Enclosure 3 to E-54837

**RAI Responses with associated application
change pages**

Environmental Requests for Additional Information

RAI PA-1

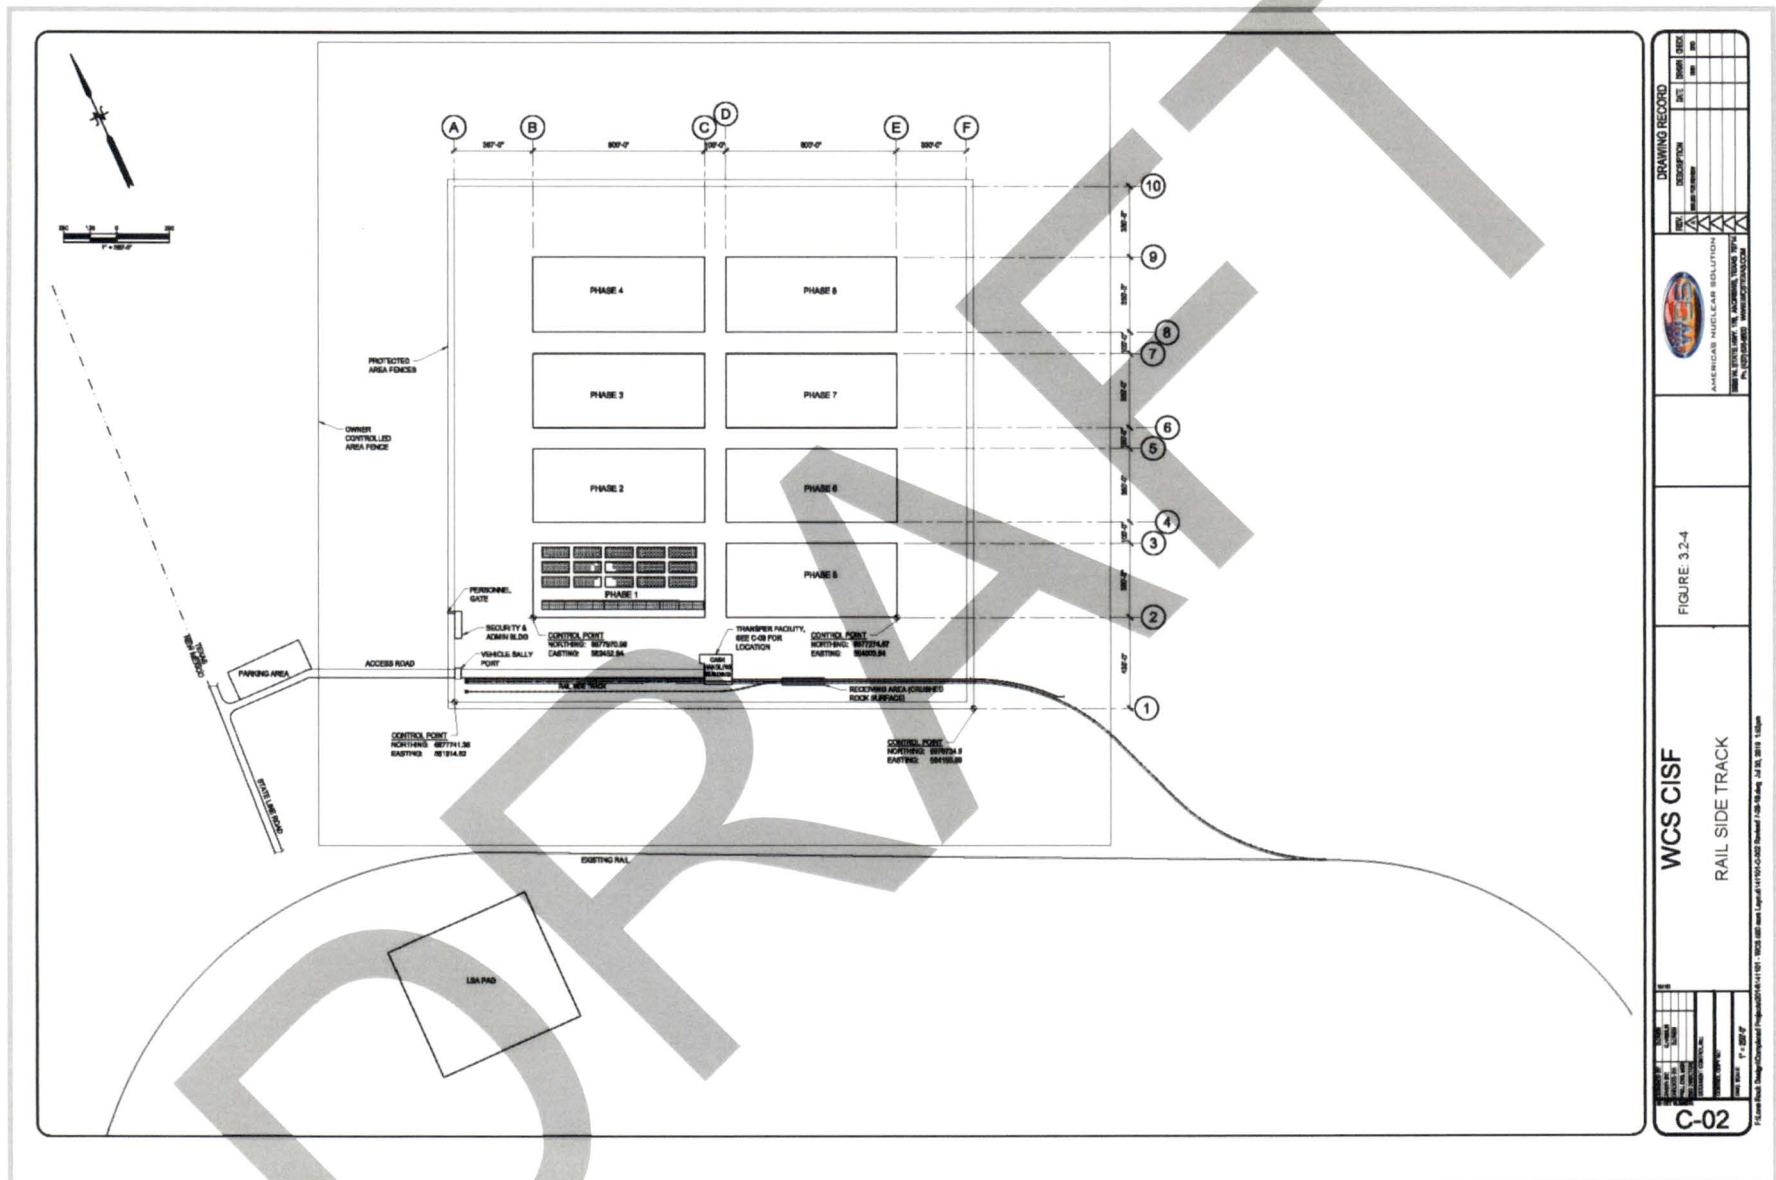
- Clarification of the location (i.e., footprint) of the railroad side track. The location of the proposed railroad side track is not consistently depicted in figures in the Environmental Report (ER). For example, compare ER Figure 2.2-6 with ER Figure 4.5-1. Specifically, clarify whether the railroad side track would cross Stateline Road into New Mexico as depicted in ER Figure 4.5-1.

- The railroad side track will be limited to Texas and will not cross stateline road into New Mexico. ER Figure 2.2-6 and the identical Figures 3.2-4 and 4.5-1 have been updated to be consistent with the side track layout. Additional figures have been updated to be consistent with the change. The affected figures are: ER Figures 2.2-6, 3.1-3, 3.2-4, 3.3-1, 3.6-1, 4.2-1 (deleted), 4.5-1, 4.12-1, 4.12-7, 4.12-8, 4.12-9, 4.12-10, 4.12-11, and 4.12-12 as well as SAR Figures 1-1, 1-2, 1-3, 2-1, 2-4, 2-15, 9-1, 9-2, and 9-6.

Figure 2-16
WCS CISF Cross Section West-East

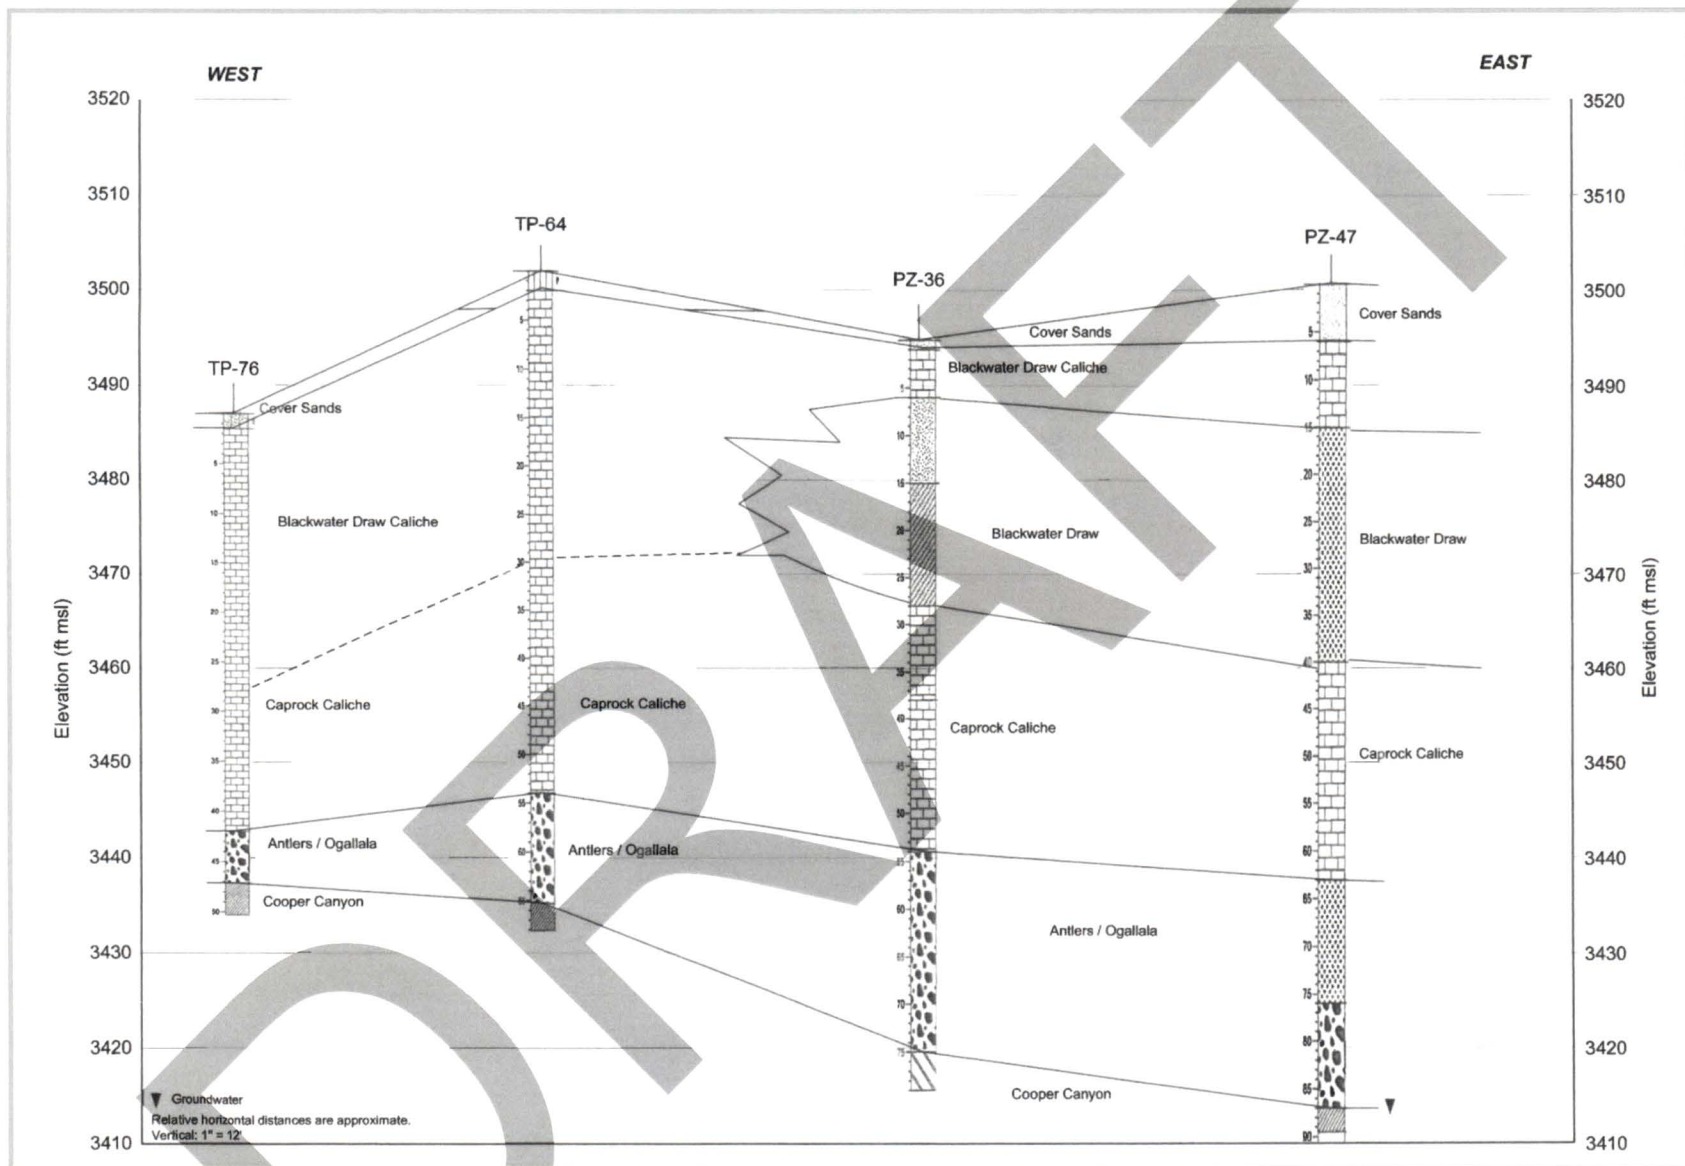
Provide geologic formation names instead of generic material labels on updates to SAR Figures 2-16 and 2-17 (i.e., geologic cross-sections). The affected groundwater environment must be clearly described.

SAR Figures 2-16 and 2-17 and ER Figures 3.3-2 and 3.3-3 have been updated to include the geologic units as opposed to the generic material labels and the location of any groundwater encountered. The geologic formation names correlate with the site-specific stratigraphic column found as Figure 2-37 in the SAR. All of the boreholes were dry when drilled with the exception of PZ-57 and PZ-47 and the monitoring wells installed in the boreholes are dry with the exception of PZ-57 and PZ-47, which are located north of the Protected Area for the proposed CISF. SAR Figures 2-16 and 2-17 have been updated to include the level of groundwater located in the monitoring wells PZ-57 and PZ-47. See RAI Response WR-5 for more information regarding the groundwater environment underlying the site.
